Subject: Rock Slope Design

Date: September 17, 2002	Author: Michael F. Oliver, P.Eng
Bulletin Number: GM02001	Action Required: Immediate
Bulletin Type: Change to Standard	Effective Date: Immediate
Contacts	Standards Affected
Michael F. Oliver, P. Eng Chief Geotechnical, Materials and Pavement Engineer Al Brown, P.Eng. Mgr. Geotechnical Services, South Coast Region	Figure 440.G Solid Rock Cut Sections Replaces the existing BC Supplement to TAC Geometric Design Guide for all roads except LVR. To be used for Preliminary and Conceptual rock ditch and rock slope design.

Figure 1 Typical Cross Section

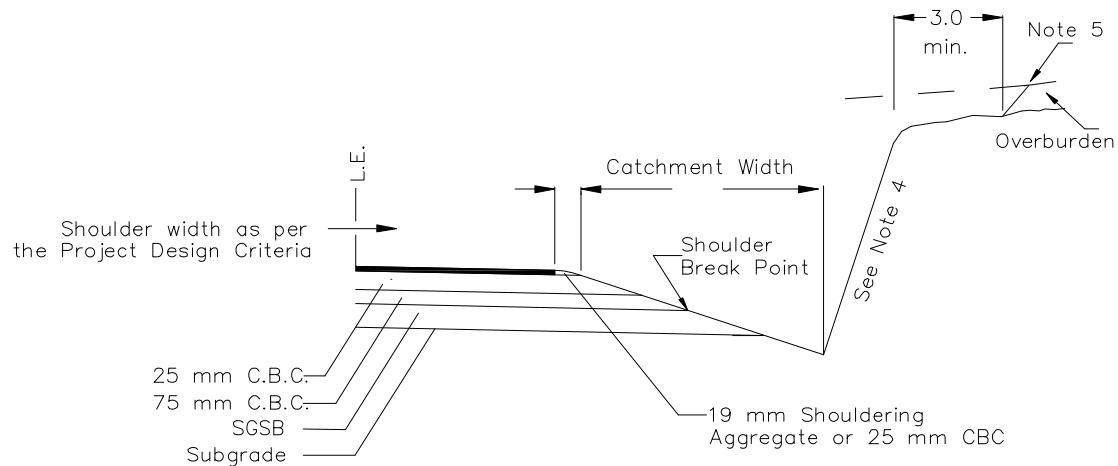
Catchment Width: Horizontal distance from the break in slope at the edge of the shoulder to the rock face as shown in Figure 1.

Catchment Slope Angle: The angle of the catchment bottom slope, down from the horizontal, extending from the break in slope at the shoulder to the rock face. The catchment slope angle to be used is 4:1. This design is effective in retaining rock to the catchment area and favored over flat bottom catchment.

1. Rock Cut Heights up to 8 m.

For rock cuts up to 8 m, catchment width is 3 m. The catchment depth is 0.75 m. There is no requirement for enhanced slope stabilization/remediation.

2. Rock Cut Heights from 8 m to 16 m.

For rock cuts from 8 m to 16 m, catchment width is 4 m. The catchment depth is 1.00 m. Enhanced slope stabilization/remediation is required for slope heights above 10 metres.

3. Rock Cut Heights over 16 m.

For rock cuts over 16 m, catchment width is 5 m. The catchment depth is 1.25 m. There is a requirement for complete remediation/stabilization of the slope.

- Catchment shape is 4:1 slope from edge of shoulder to rock cut face and slope angle is 0.25 to 1.
- Where natural slopes exist above the excavated rock slopes and these slopes have potential stability problems, an increase in the remedial stabilization measures will be required.
- Detailed design will be based on site specific conditions determined from detailed site investigation.

1. Rock cut height is measured from the outside catchment point to the top of the rock face, excluding overburden.
2. All rock cuts to be excavated to subgrade line.
3. A geological investigation is to be carried out for all cuts greater than 8 m and for all cuts where natural slope extends upward beyond section limits.
4. Use 1:4:1 backslopes unless a different slope angle is recommended in a geological investigation.
5. Overburden slope is normally cut to 1.5:1 but can be varied, depending on the type of material.
6. Barrier, clear zone and drainage requirements will be reviewed in the detailed design phase.
